**SAN FRANCISCO UNIFIED SCHOOL DISTRICT  
2011 PROPOSITION A BOND PROGRAM  
PRESIDIO MS BOILER REPLACEMENT PROJECT**

**ADDENDUM NO. 2**

**PROJECT:** Presidio MS Boiler Replacement  
450 30<sup>th</sup> Avenue, SF 94121

**DATE:** January 31, 2014

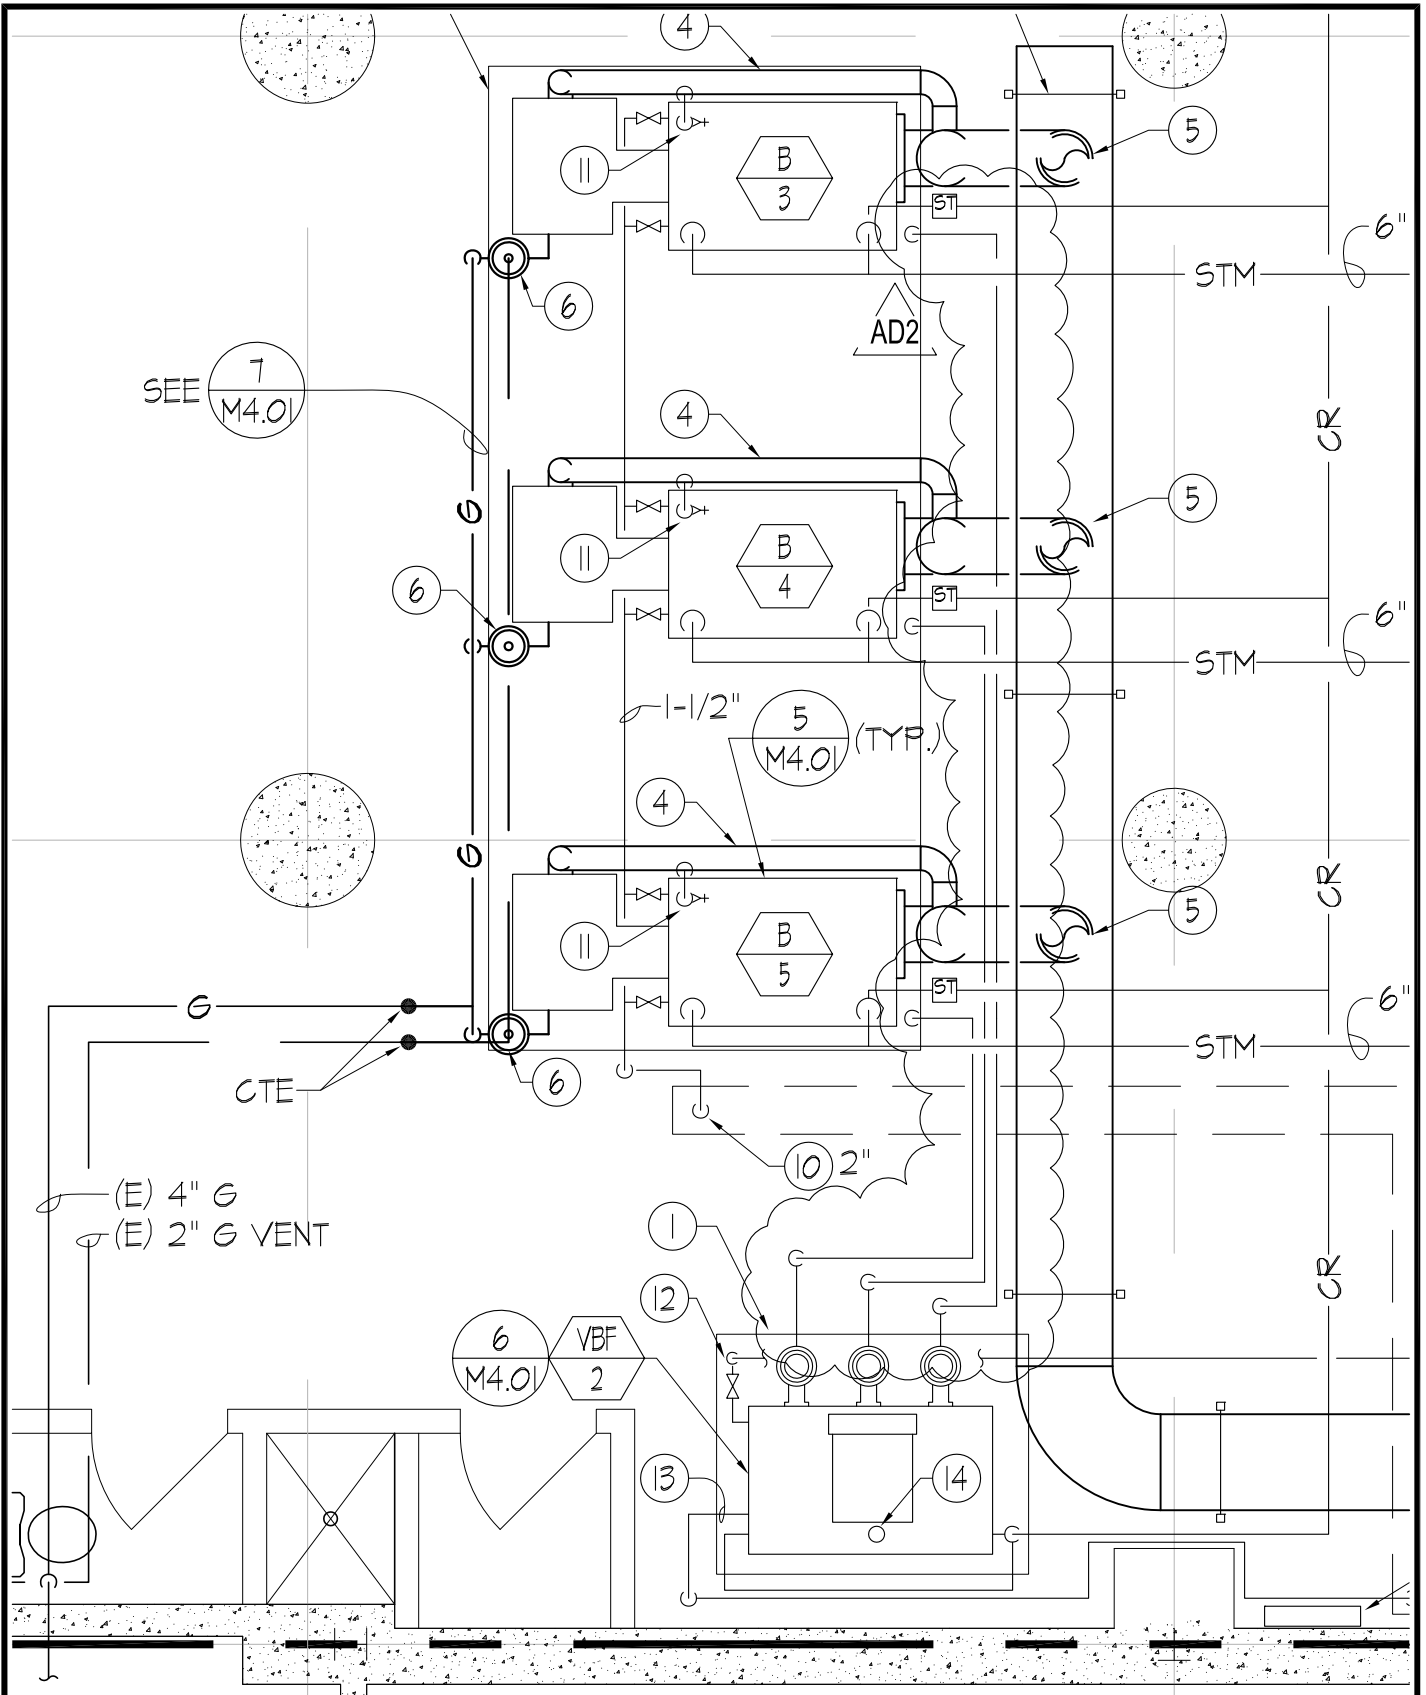
**3. ITEM NO. AD2-3**

**Sketch: AD2-MSK-1**

**Reference: M2.01**

Description: Revise piping at boiler per attached sketch

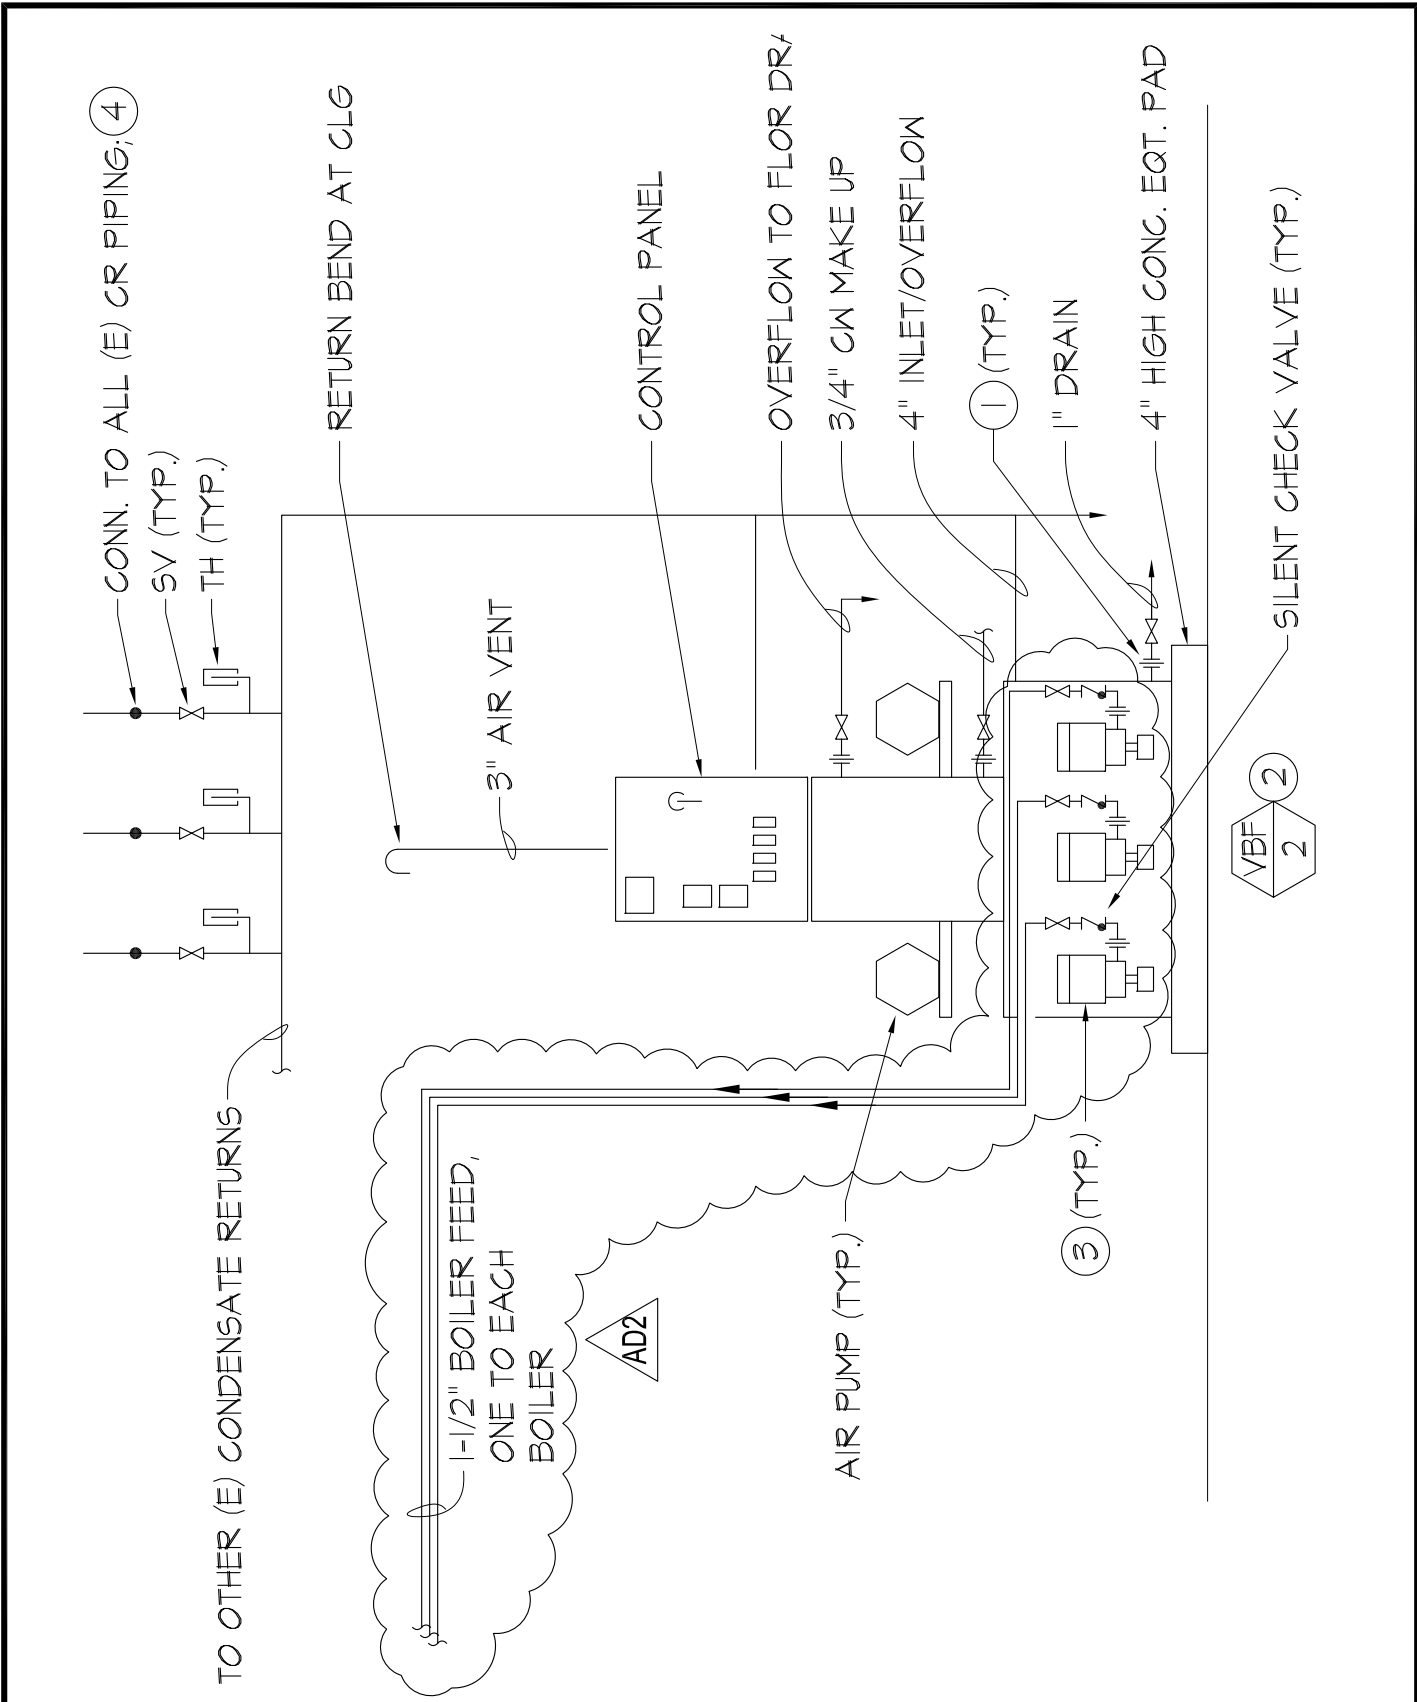
**5. ITEM NO. AD2-5**

**Sketch: AD2-MSK-3**

**Reference: M4.01**

Description: Revise piping at boiler per attached revised detail #6
